OFFICE COPY
FOREST LAKES WEST THIS PLAT APPROVED BY THE SUBDIVISION
 AN ADDITION TO WICHITA, SEDGWICK COUNTY, KANSAS COMMITTEE ON 7-10-97 SUBJECT
 TO THE CONDITIONS OF APPROVAL OUTLIN-
 ED IN OUR LETTER DATED 7-11-97

Re: S/D 97-3 -- Final Plat of FOREST LAKES WEST ADDITION

Re: S/D 97-3 - FINAL PLAT OF FOREST LAKES WEST ADDITION

CASE NUMBER: S/D 97-3 - FOREST LAKES WEST ADDITION

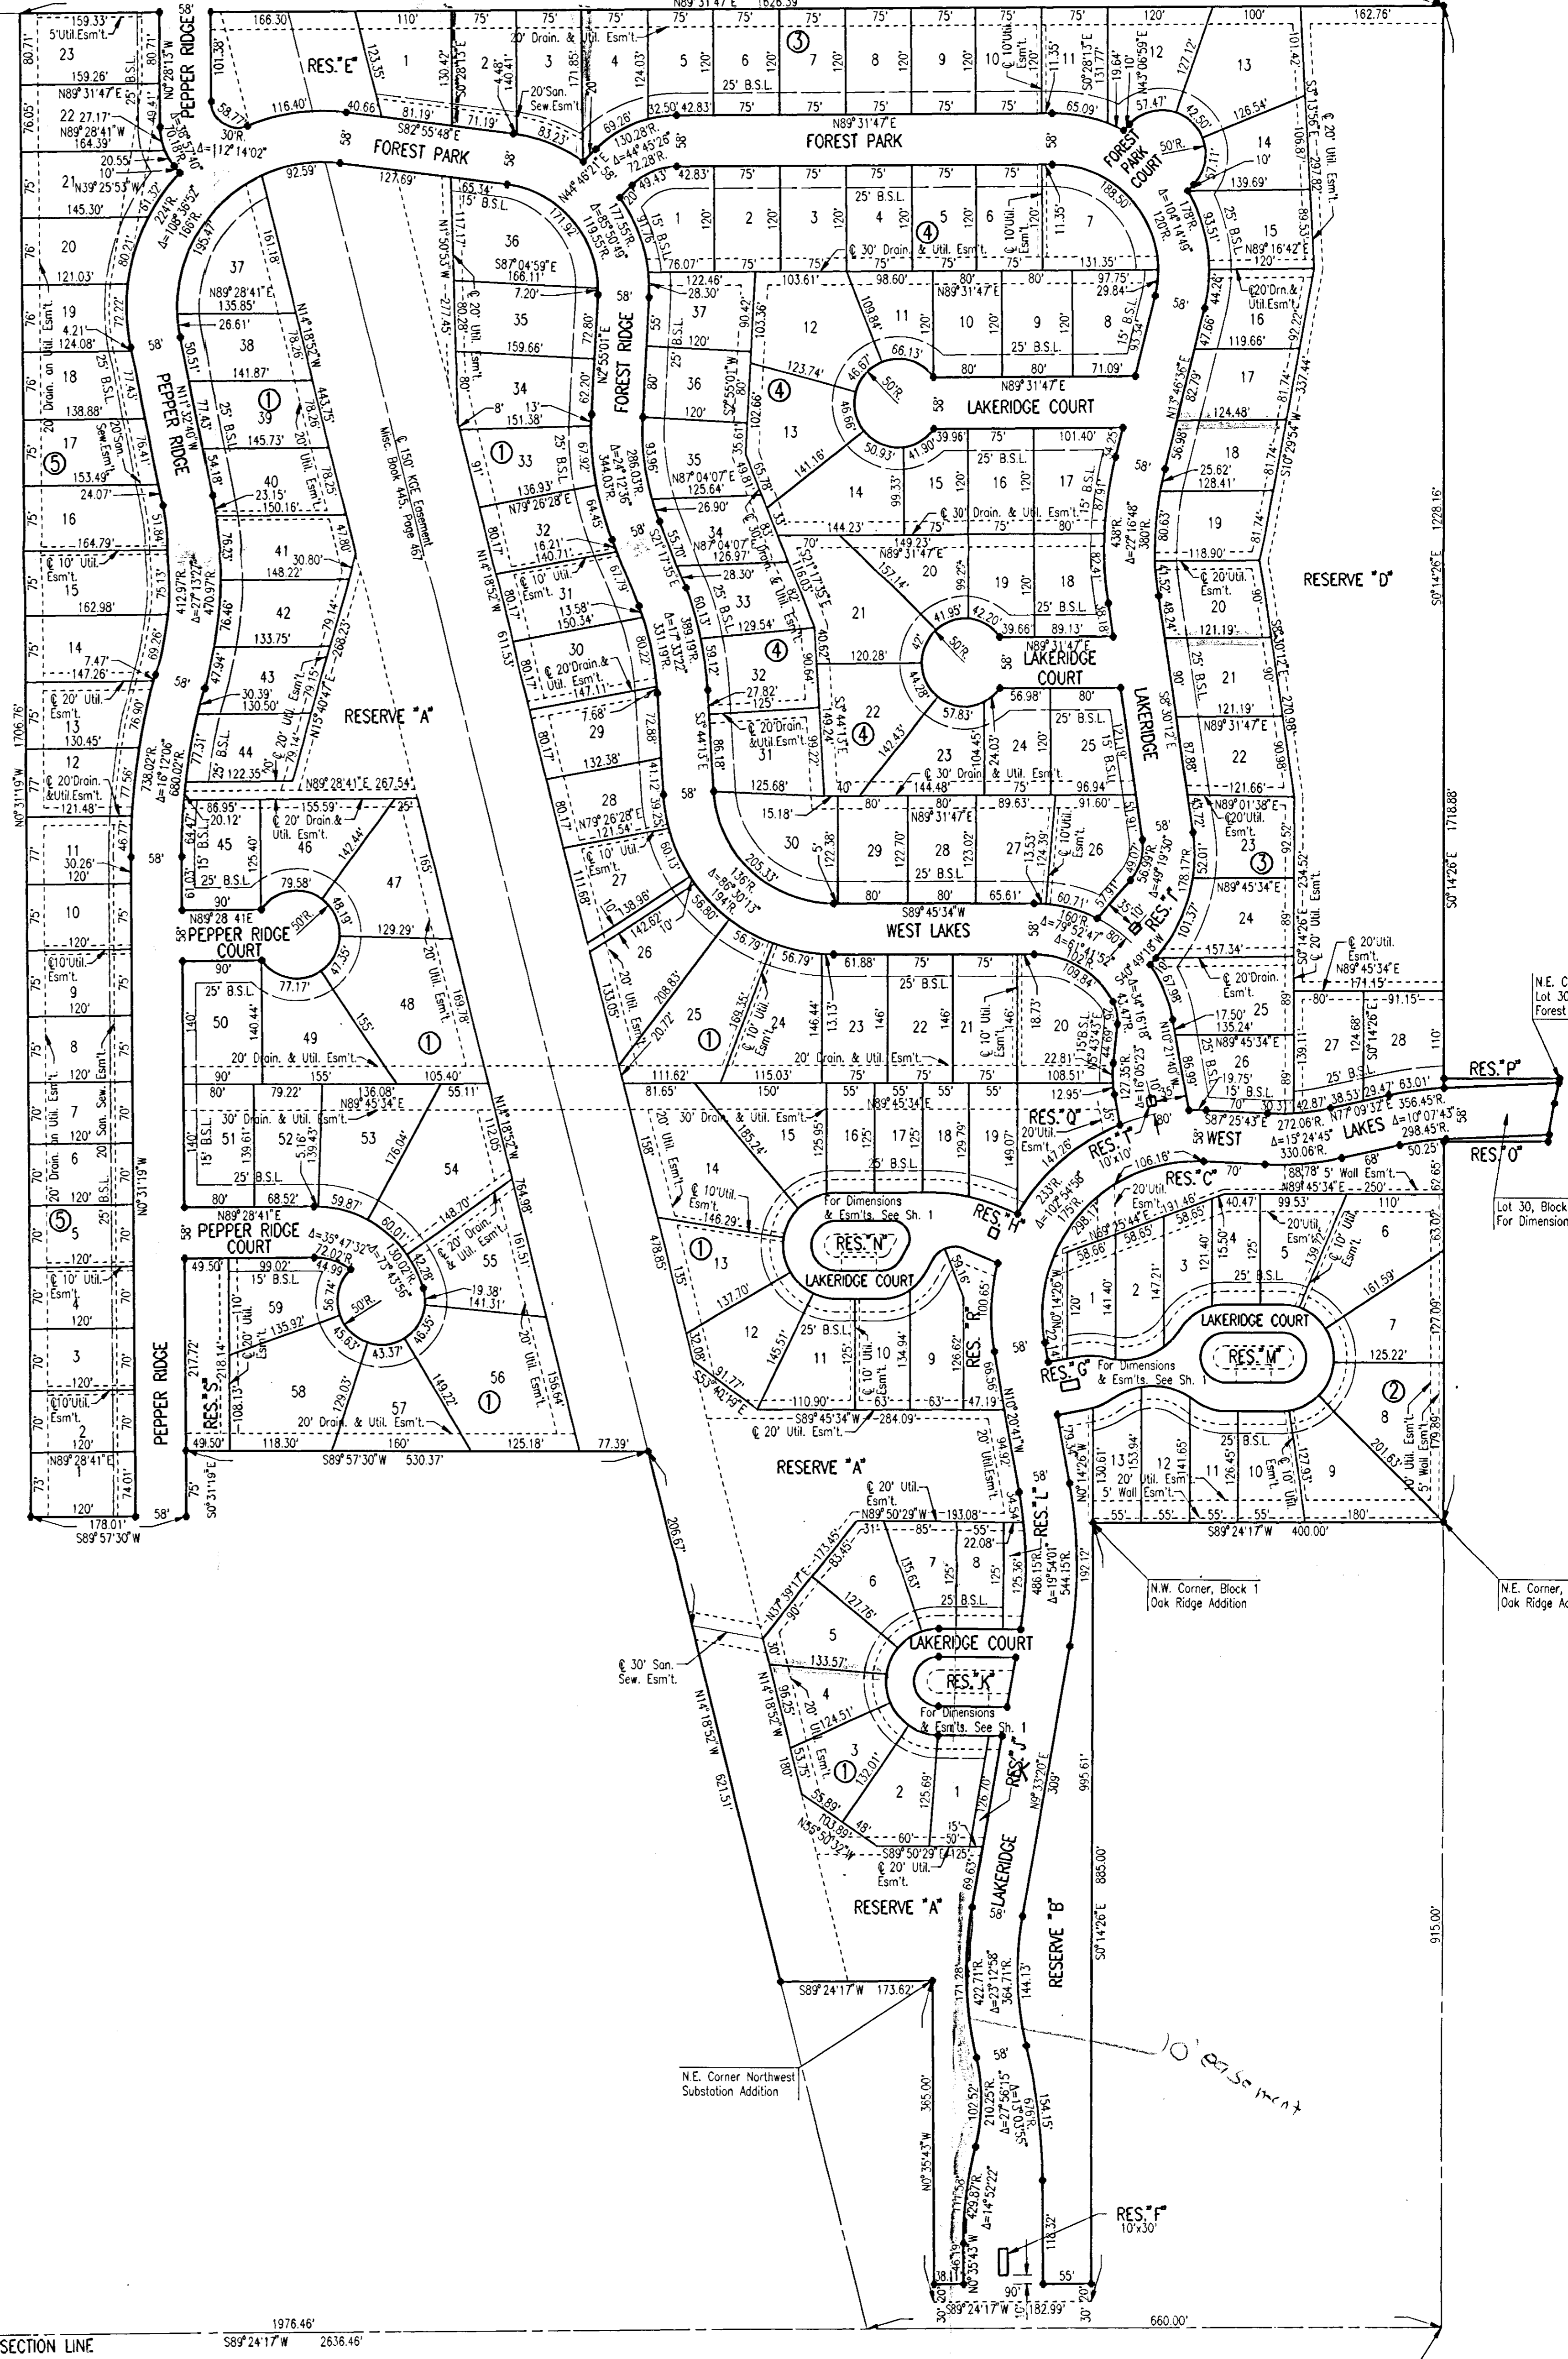
I. Depending when this and the adjacent plat are actually recorded, but also as to when development actually occurs, a temporary turn around could be needed for Pepper Ridge at this plat's southern line. That is, if this site develops before Oakridge 2nd, a temporary turn around will need to be provided. City Engineering needs to indicate if an on-site or off-site turn around would be involved and what type of improvement should be included in the above paving guarantee. No temporary turnaround is needed. The applicant should meet with Traffic Engineering about reserves being platted in the middle of the street.

J. The platting of off-street parking areas, such as is proposed for Reserves K, M and N needs to adhere to "policy statement 13" of the MAPC. While in general, this policy involves the designation of such parking areas through the CUP process, when no CUP is involved as in this plat, the conditions and standards of policy statement 13 is still used as the guidelines to be followed.

In particular, such areas are to be shown as parking "easements" and need to be referenced in the plat's text. For Reserves M and N, the parking areas shall be changed to such easements and not depicted as street right-of-way. For all three reserves, these easements need to be at least 20-feet deep, but no wider (frontage) than 50-feet. For Reserve J, the parking area needs to be designed so as not to interfere with the 15-foot street-drainage-utility easement requirements for 32-foot streets.

K. On the final plat, complete access control shall be shown to 29th Street North from Reserves A and B.

The final plat appears to comply with policy 13 standards.
